**Committee of Experts on the Transport of Dangerous Goods
and on the Globally Harmonized System of Classification
and Labelling of Chemicals****Sub-Committee of Experts on the Transport of Dangerous Goods****Forty-ninth session**

Explosives and related matters:**review of tests in parts I and II of the Manual of Tests and Criteria****Supporting material for the new design proposal for the
standard detonator in the Manual of Tests and Criteria****Transmitted by the expert from Germany¹****Introduction**

Under water tests results with the standard detonator

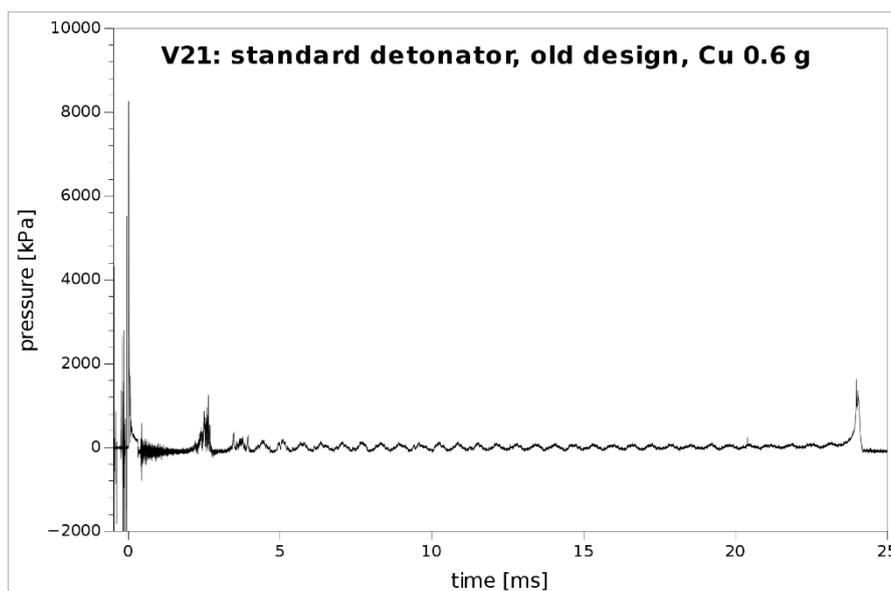
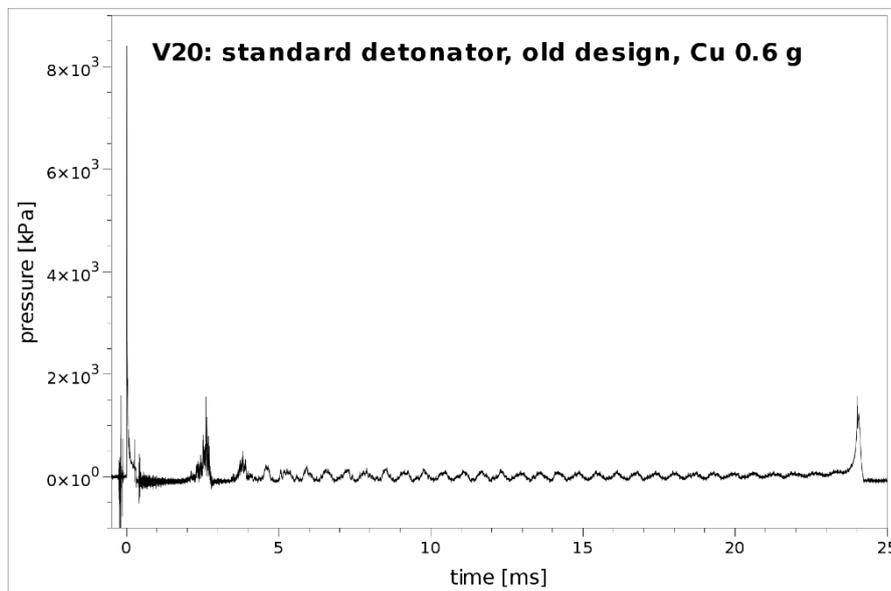
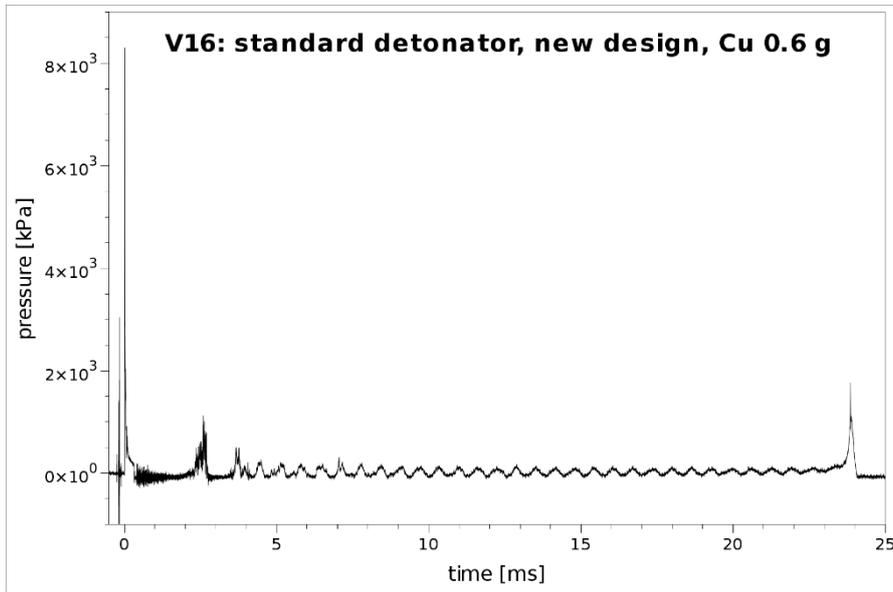
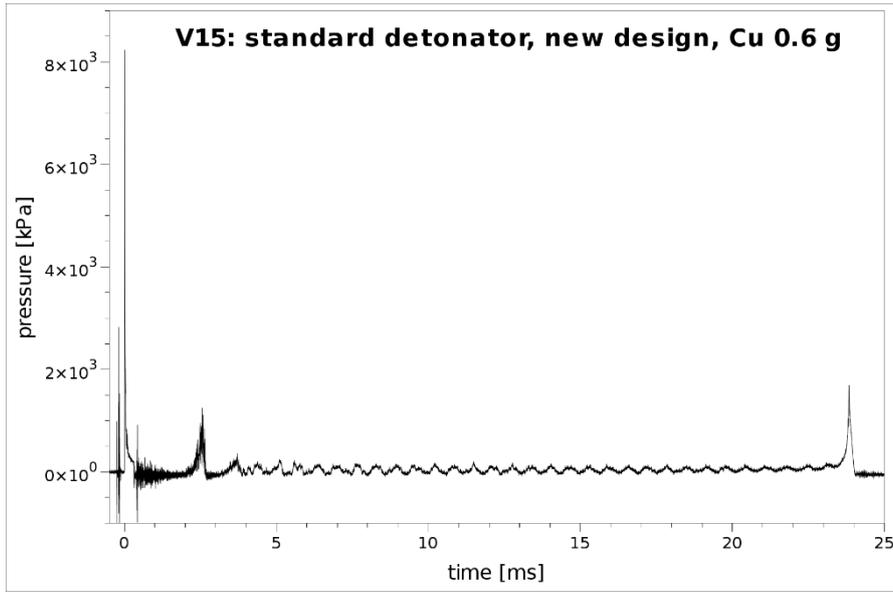
1. The following graphs show pressure traces recorded at BAM (Federal Institute for Materials Research and Testing, Germany). The tests are referenced by their original numbering as V20 and V21 for the original detonator design (0.6 g PETN main charge, Copper shell, produced by dyniTEC in Germany). For comparison a detonator with 0.6 g PETN main charge and a Copper shell produced by Austin Detonator, Czech Republic, which contains all elements of the new standard detonator design, was also subjected twice to the underwater test numbered V15 and V16. A table summarizes the values taken from the original data.

Date	Test no.	Detonator design	Peak pressure [MPa]	Time till collapse [ms]
2015-09-02	V20	Old	8.41	24.04
2015-09-02	V21	Old	8.26	24.02
2015-09-02	V15	New	8.23	23.83
2015-09-02	V16	New	8.30	23.88

5. It is proposed that, on the basis of experimental evidence given in this and previous papers, the specification of the standard detonator, is amended. The amended design shall be based on the proposal in ST/SG/AC.10/C.3/2015/26, taking into account the comments given in the report of the Working Group on Explosives (Informal document INF.53, 47th session).
